MEMORANDUM

SUBJECT: FM 620 and Anderson Mill Road SER #4652

Exhibit A

SUBJECT: Broadstone 620/ Birden Multi-Family Wastewater SER #3880

W.W. S.E.R. Name: FM 620 and Anderson Mill Rd - Option 1

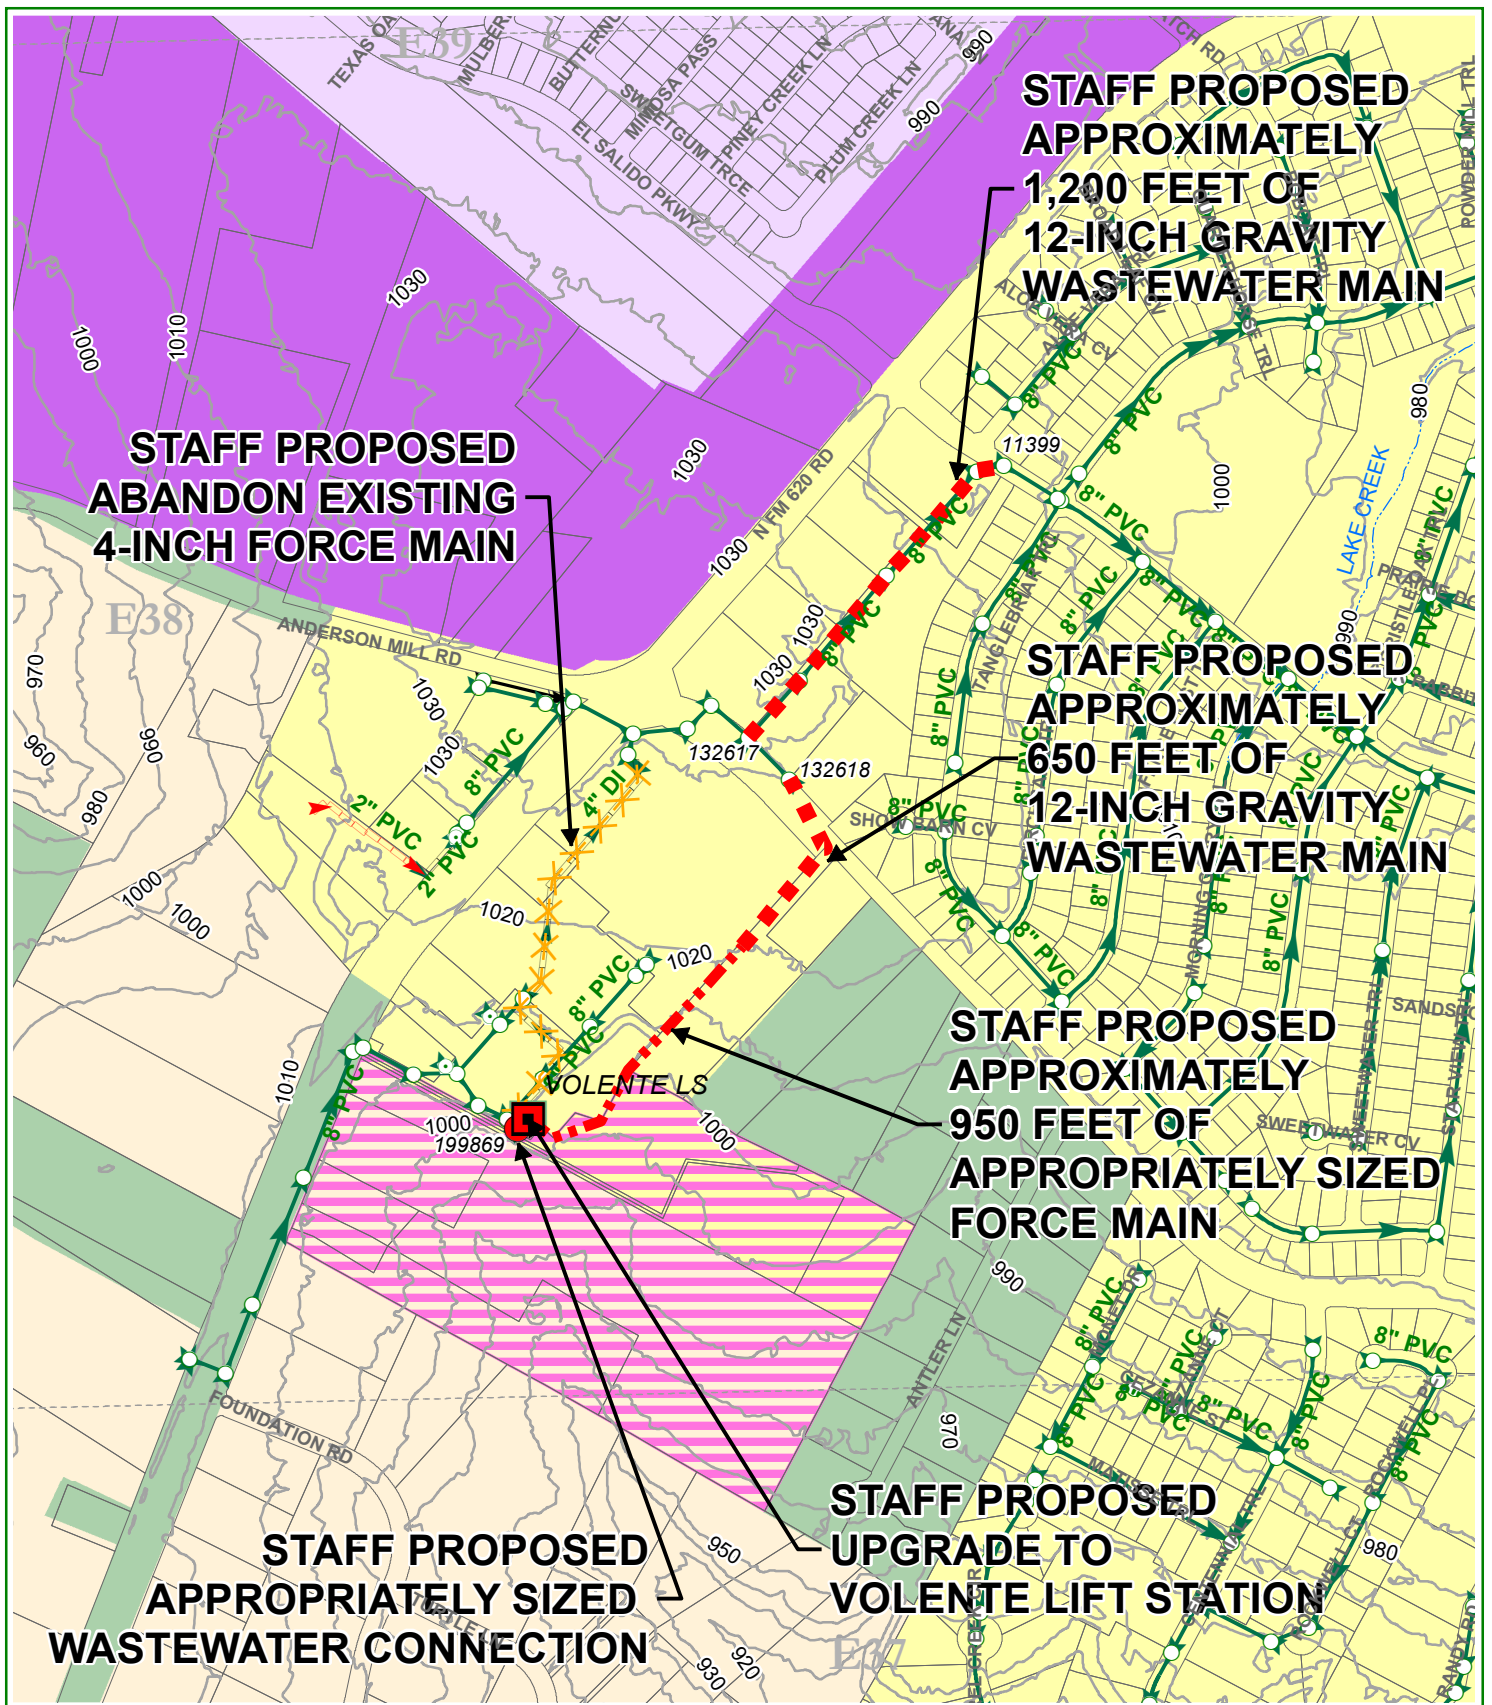
Applicant shall construct approximately 1,600 feet of 12-inch gravity wastewater main from the existing 8-inch gravity wastewater main (Project no. 80-0629; MH ID #11399) located in El Salido Pkwy., southwest towards Anderson Mill Rd. to the existing 8-inch gravity wastewater main as shown on page 1 of the attached maps. The proposed 12-inch gravity wastewater main shall replace the existing 8-inch gravity wastewater main (Project no. 2002-0552) along this path and all existing services shall be reconnected to the proposed 12-inch gravity wastewater main.

Applicant shall also make an appropriately sized wastewater connection to the existing 8-inch gravity wastewater main located south of the Volente Lift Station at the location shown on the attached map. Applicant shall also upgrade the pumping capacity of the existing Volente Lift Station to a firm capacity of approximately 355 gpm in order to adequately serve the additional wastewater flow proposed to be contributed by this development. Upgrades shall include, but are not limited to, replacement of existing pumps, generator, and electrical system (including starters, wiring, service, control panel, etc.).

Applicant shall also construct approximately 1,350 feet of appropriately sized force main from the existing Volente Lift Station, north and northwest across the adjacent property, to the existing 6-inch gravity wastewater main located east of N. FM 620 and south of Anderson Mill Rd. The proposed force main shall replace the existing 4-inch force main located along this path.

Due to the significant potential environmental impacts to the site with the extension of wastewater service, Watershed Protection Department staff do not recommend support for wastewater SER #4652.
